Case No. P/8 209/34

With reference to your application dated ~~22/3~~ 19-4-34
with a plan for the proposed building/additions and alterations on plot
No. 31/3, Survey Sheet No. J. V. 3, Jamshed Quarter
I have to request you to comply with the following requirements:—

PROPOSED BUNGALOW ON PLOT No.37/3. J.M. 3

HYDERABAD AMIL CO-OPERATIVE HOUSING SOCIETY.

PROPOSED BUNGALOW ON PLOT No.37/3. J.M. 3.

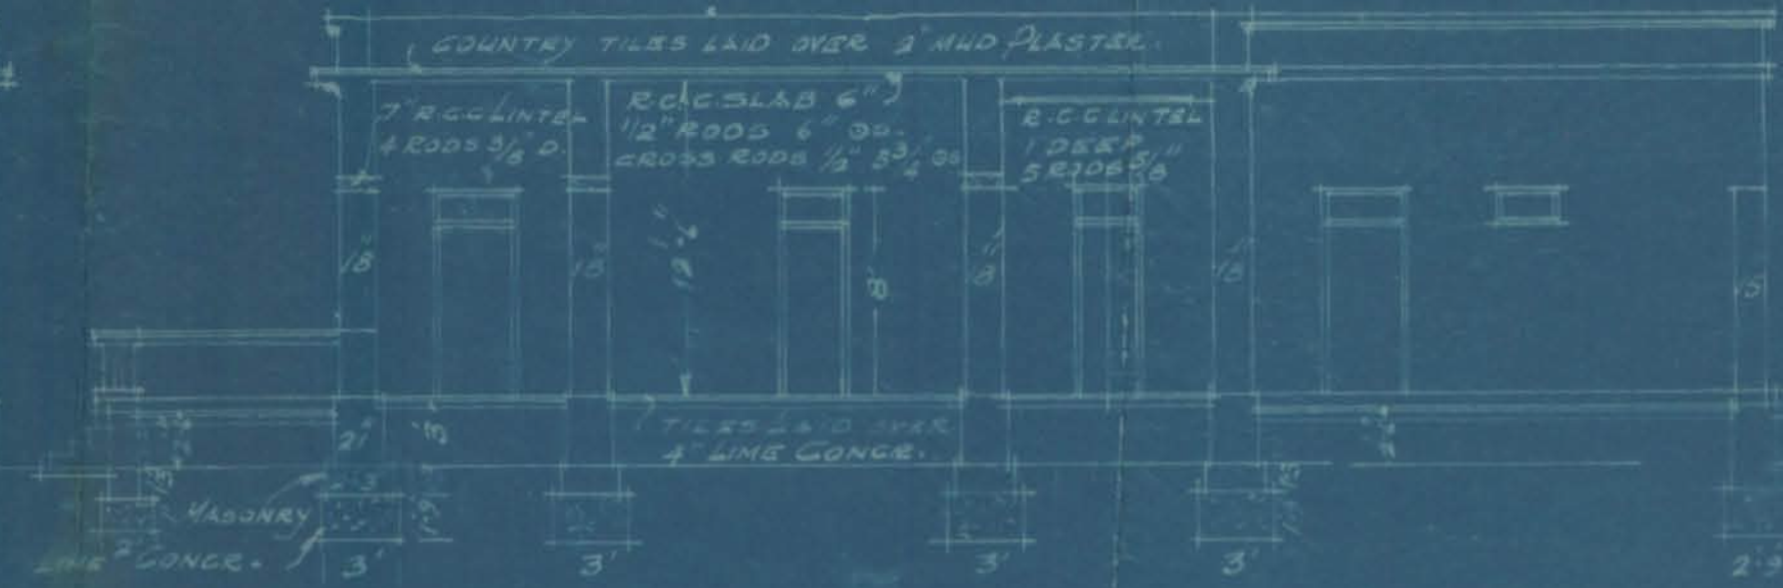
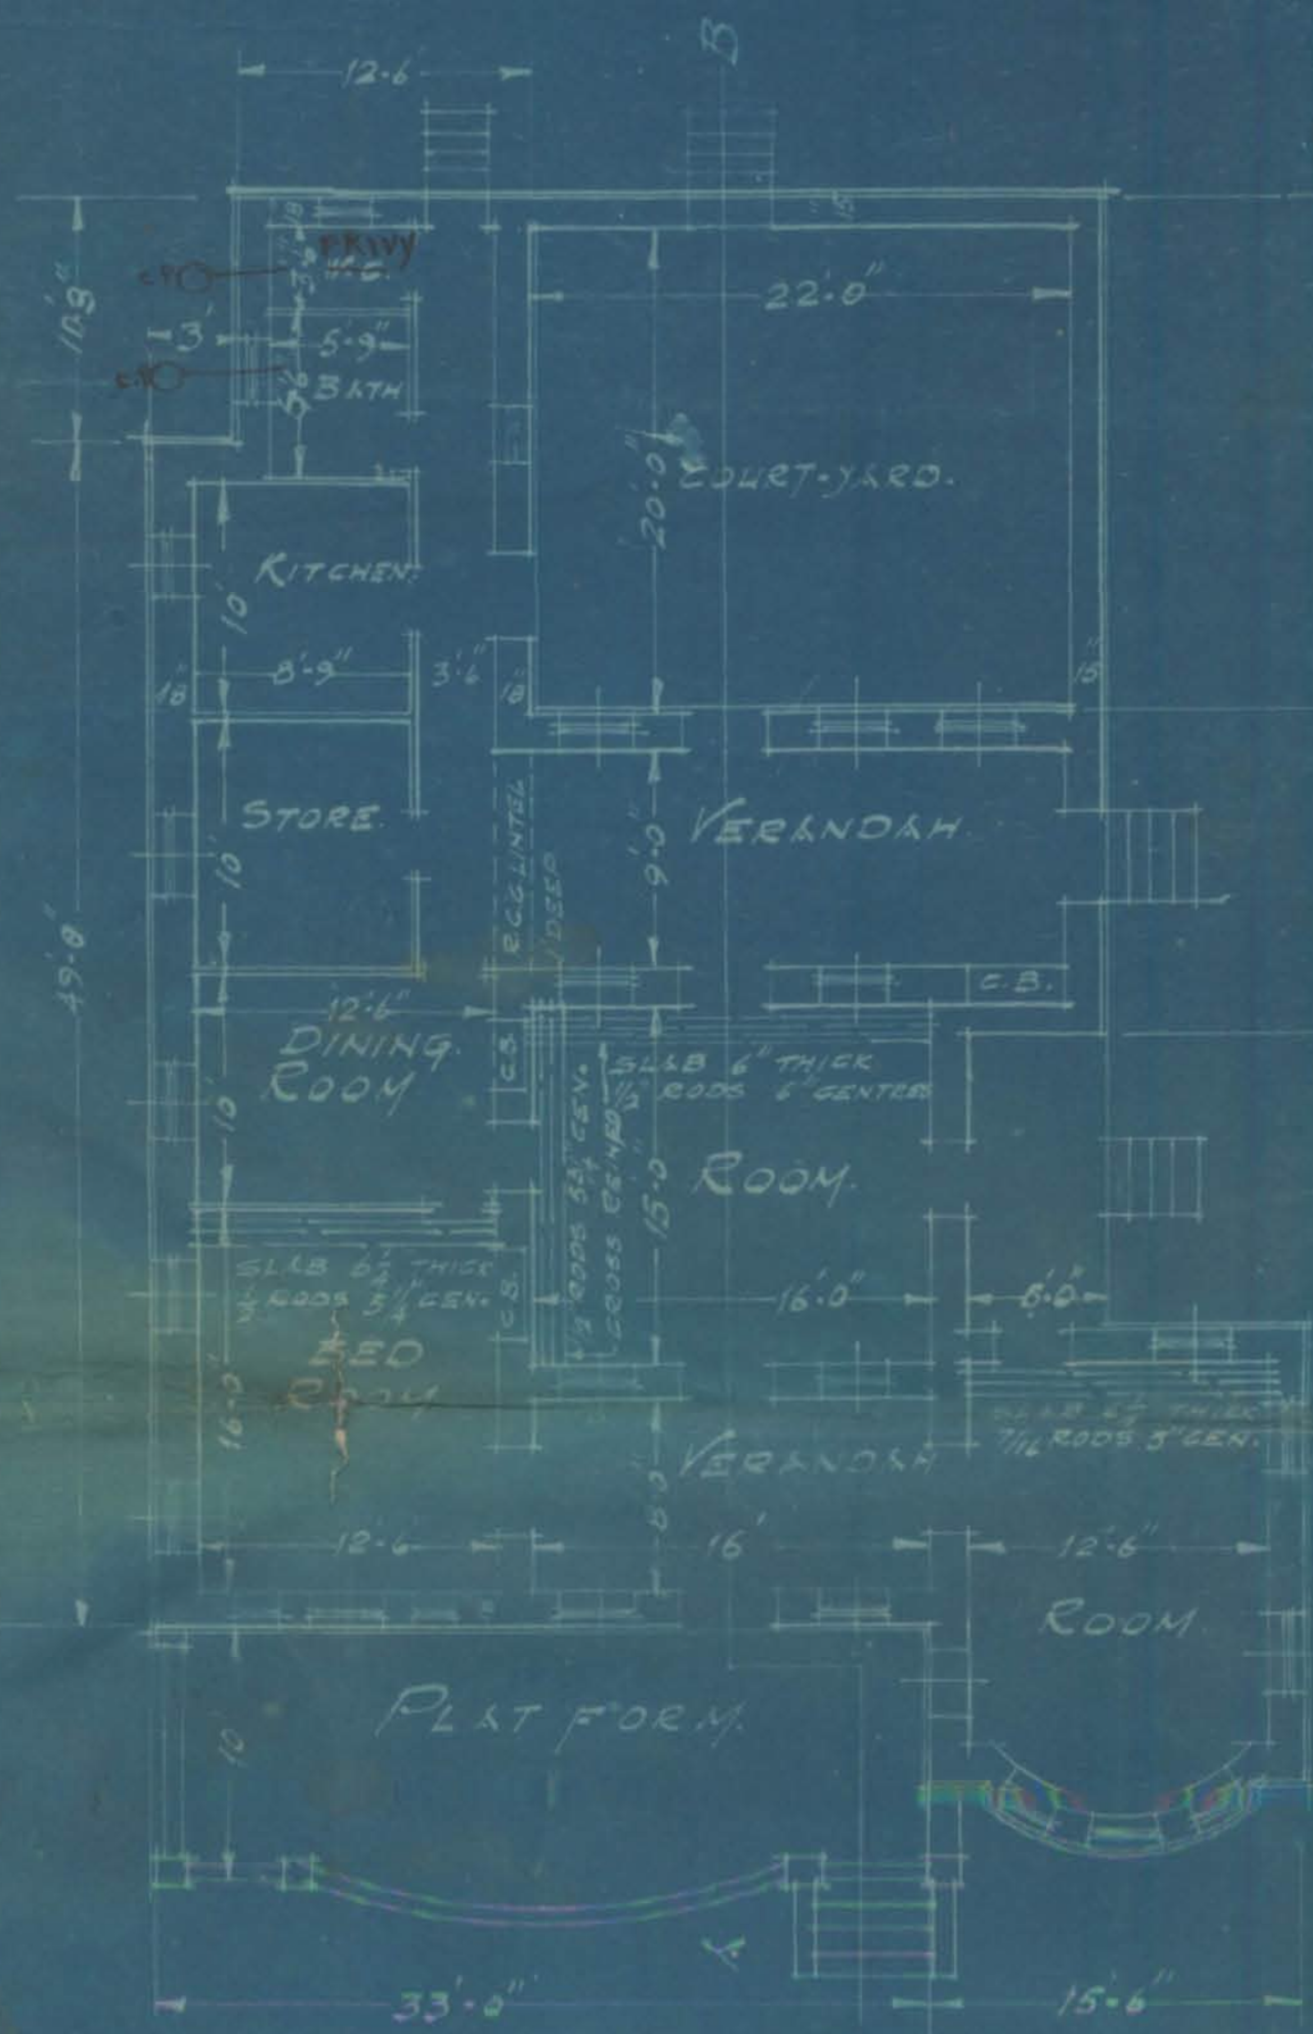
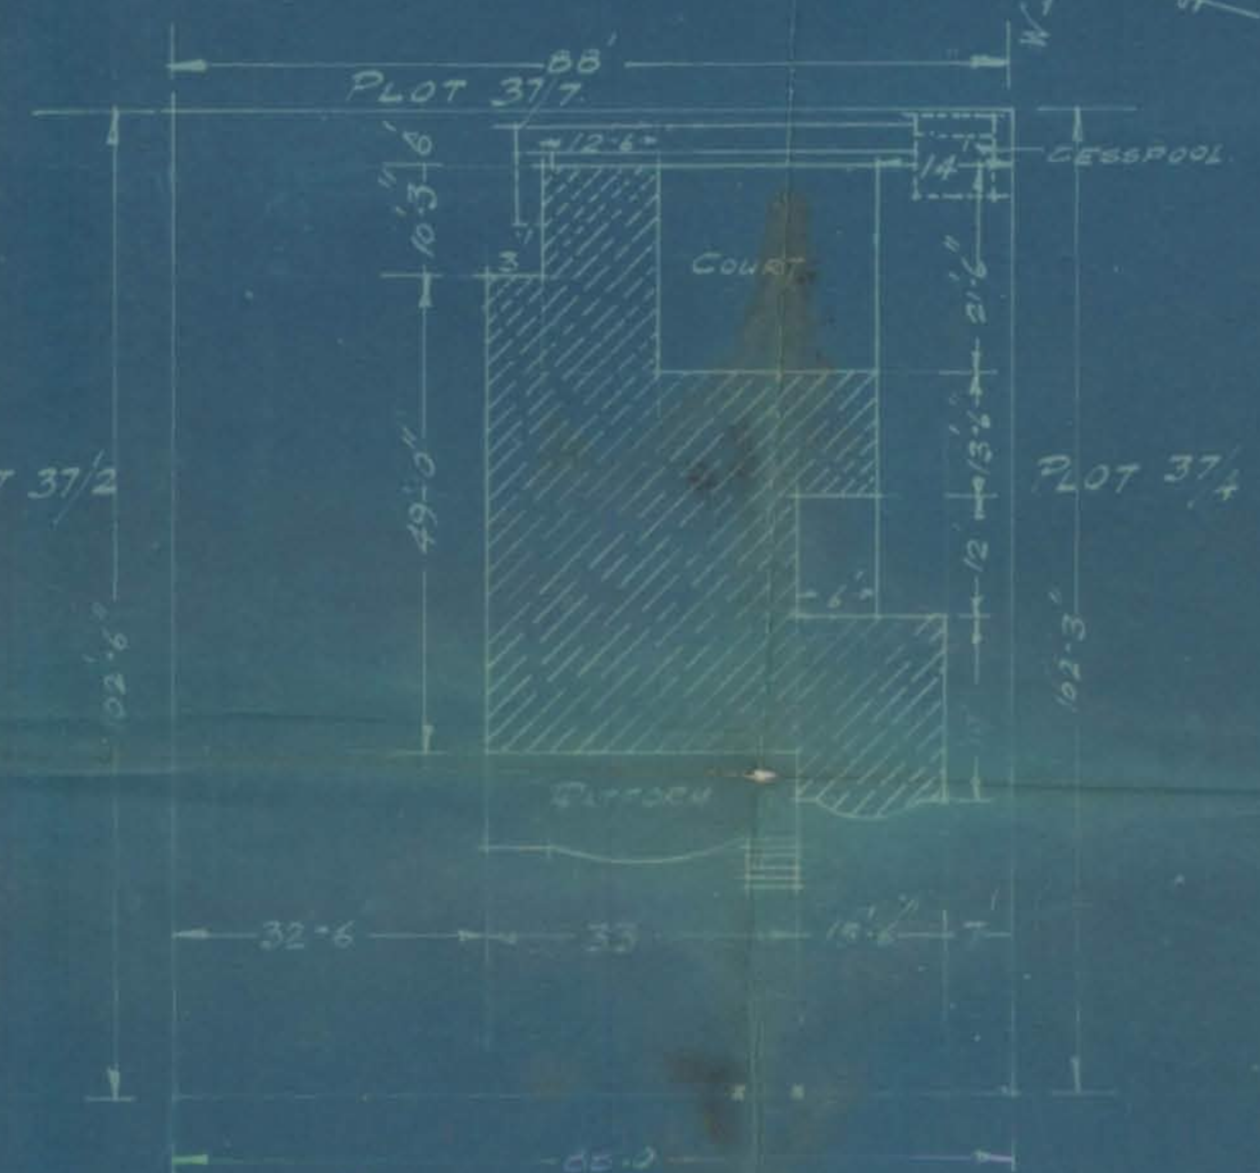
28/8
res. cannot be
permitted
29/8

I send herewith amended plan of building on plot No. 37/3 -
J.M.3 - for your approval.

No objection to plans as corrected
